TOWN OF HUDSON
PLANNING BOARD

Subject: Hawkview Subdivision (ZBA Input Only)
White Service Road & Kara's Crossing Drive
Map 186/Lots 20-1 & 24; Map 194/Lot 10; Map 195/Lot 1; Map 201/Lot 7

PURPOSE OF PLAN: to propose a 16-lot OSD Residential Subdivision at 4 Bockes Road, which consists of 26.82 acres +/- . This development also proposes to extend York Drive in order to create a 3-lot conventional subdivision. Deferred Date Specific from the July 8, 2015 Planning Board Meeting.

Re: Town of Hudson Planning Board Review
Rolling Woods Subdivision, 4 Bockes Road
Tax Map 144, Lot 21, PO #1350-840
CLD Reference No. 03-0249.1370

DATE: MAY 23, 2014 SCALE: 1" = 100'
 PROJECT NO: 13-0702-1 SHEET 1 OF 27

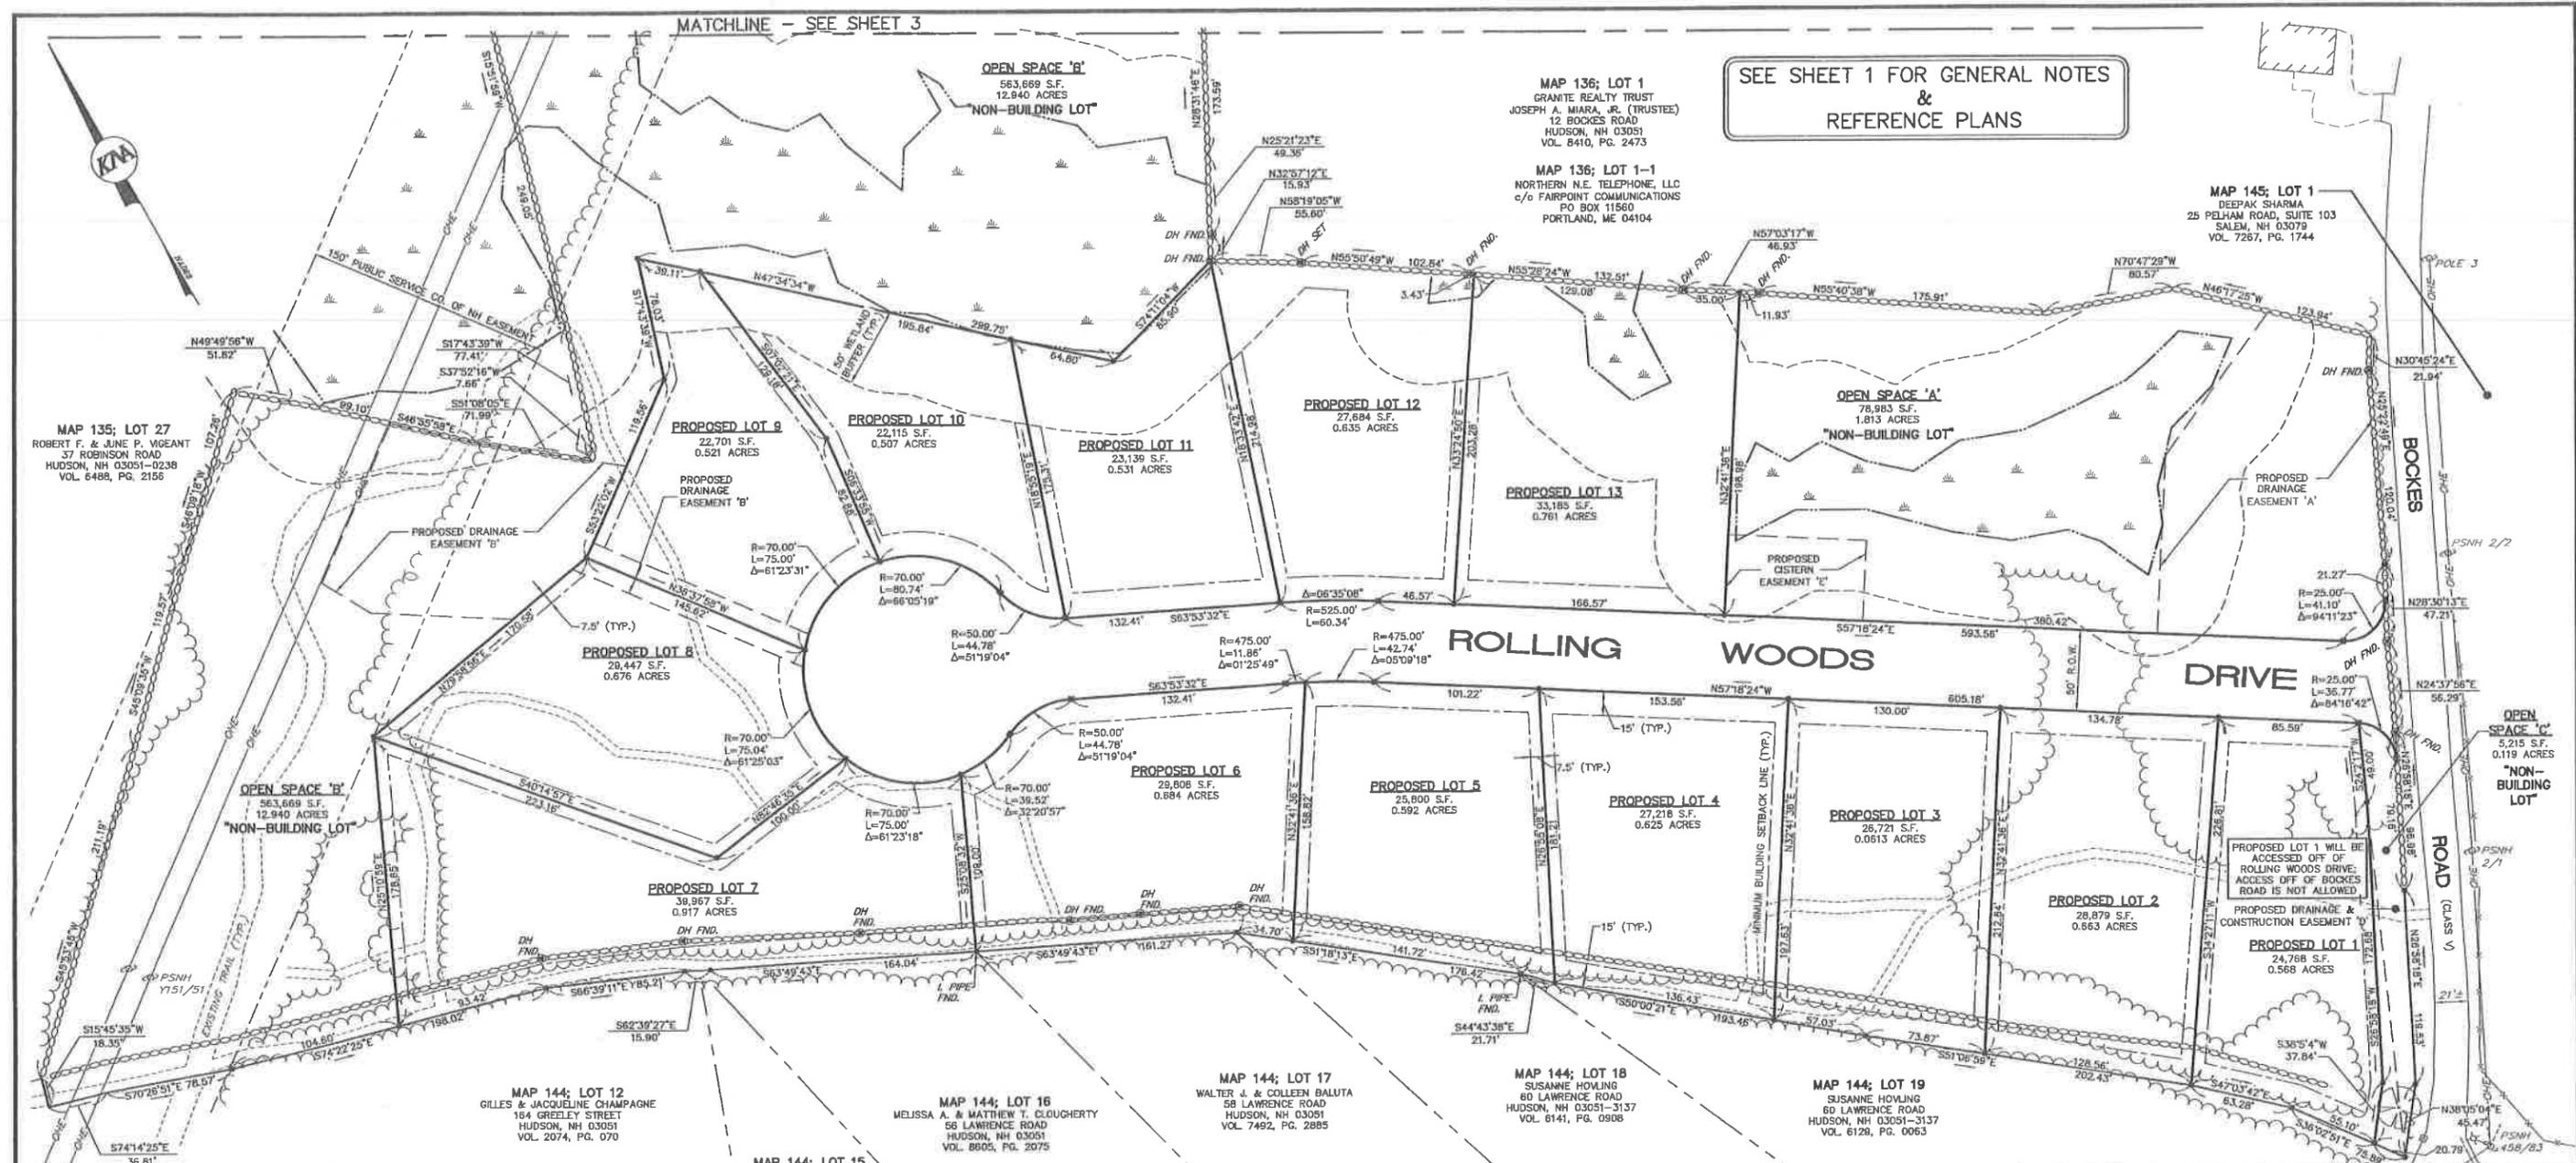
- 5) Note 20 needs to be amended to reflect the accurate CAP Fee amount of \$787.48.
- 6) Please note, the Plans are signed and stamped by: Steve Keach, P.E., Anthony Basso, LLS, and Steve Schauer, CWS (all are certified to practice their respective professions in the State of NH).

3. A CAP amount of \$787.48, per residential unit, shall be paid prior to the issuance of a Certificate of Occupancy. Prior to Planning Board endorsement of the Plan, Note 20 on Sheet 1 of 27 shall be amended to reflect said CAP Fee amount.

20. A CAP IN THE AMOUNT OF \$786.00, PER RESIDENTIAL UNIT, SHALL BE PAID PRIOR TO THE ISSUANCE OF A CERTIFICATE OF OCCUPANCY.
21. A PUBLIC SCHOOL IMPACT FEE IN THE AMOUNT OF \$3,578.00, PER RESIDENTIAL UNIT, SHALL BE PAID PRIOR TO THE ISSUANCE OF A CERTIFICATE OF OCCUPANCY.

DATE: MAY 23, 2014 SCALE: 1" = 50'
 PROJECT NO: 13-0702-1 SHEET 10 OF 27

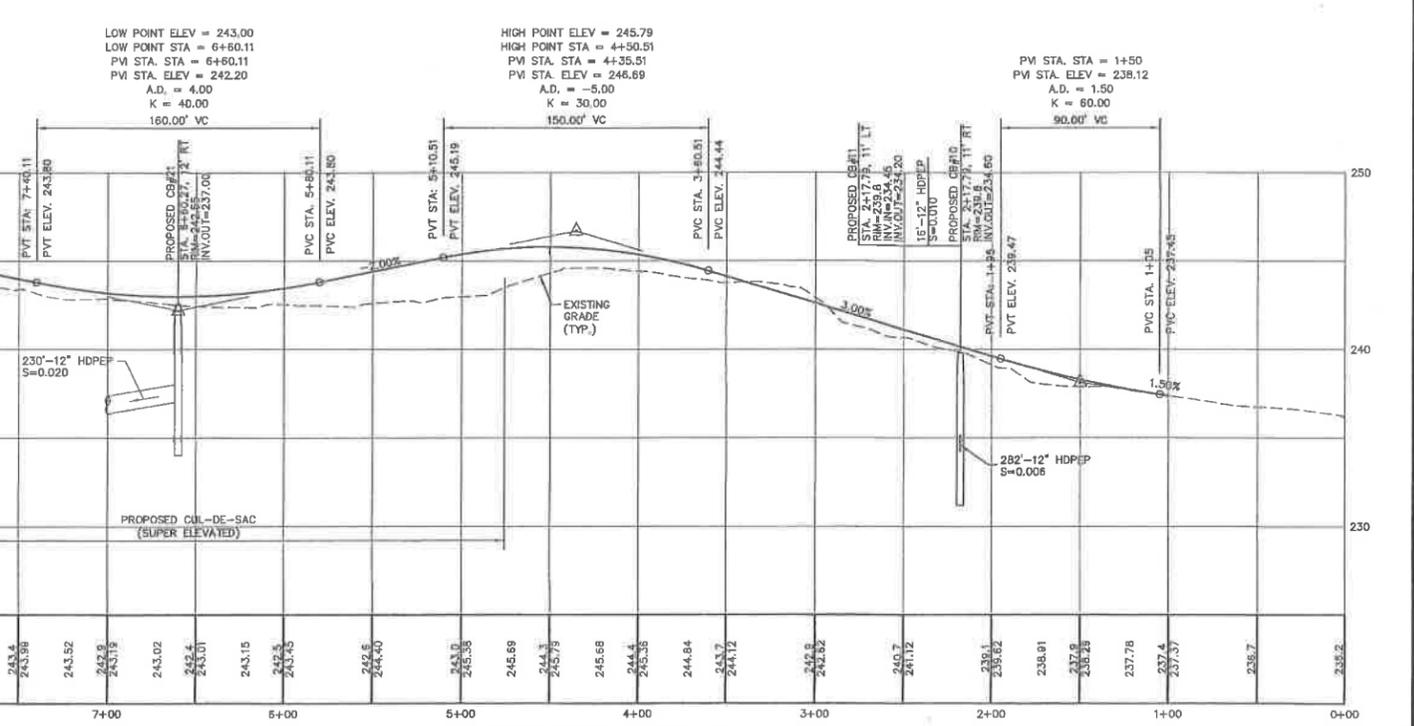
Note #2 was added to plan sheet 10 to reflect what was recommended above.

30,000 GALLON CISTERN PLAN DETAIL

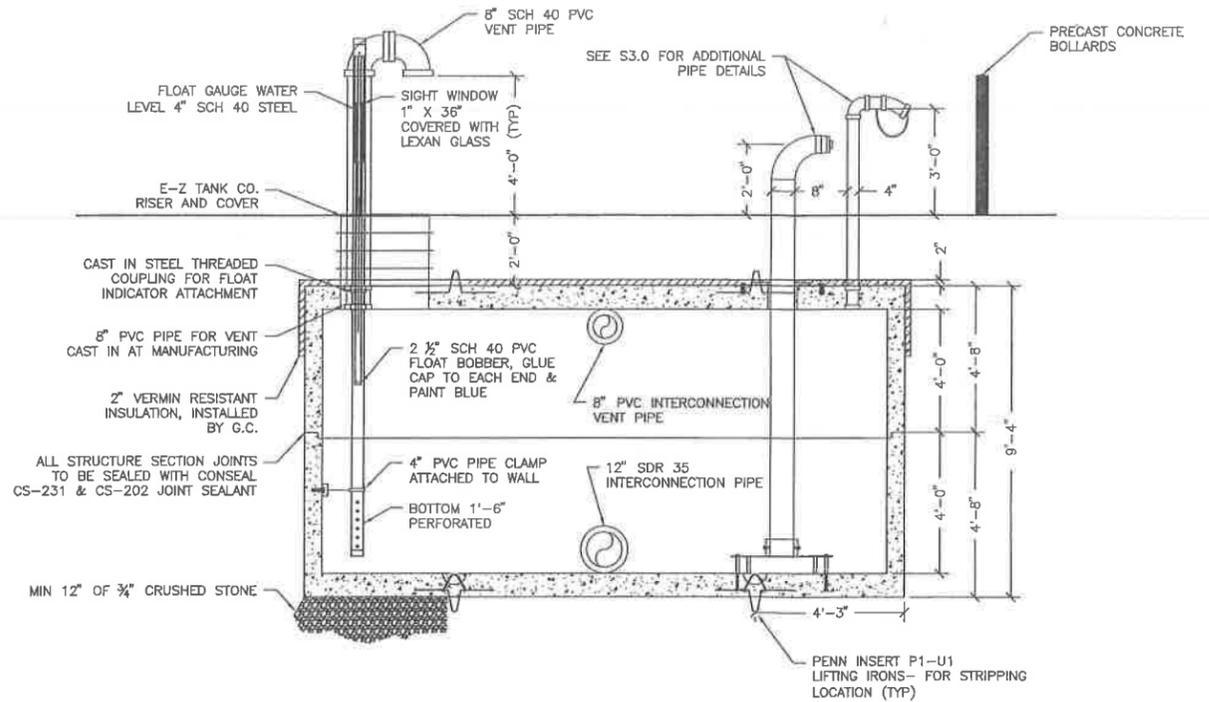
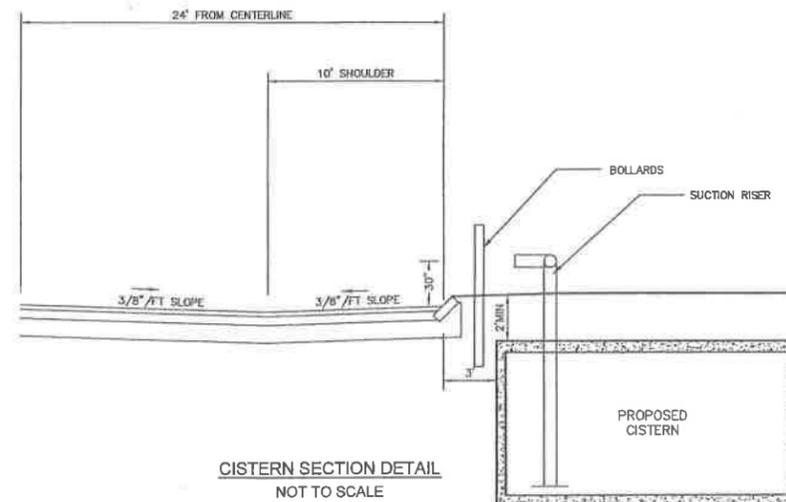
- a) Each of the 16 proposed lots will be serviced by individual wells.
 - b) There will be 2 cisterns, i.e., a 30,000 gallon and 10,000 gallon. One will be located along Rolling Woods Drive, off Bockes Rd., and the other off York Dr. Please refer to Sheets 3 & 4 of the Plan set for the specific location of each cistern.
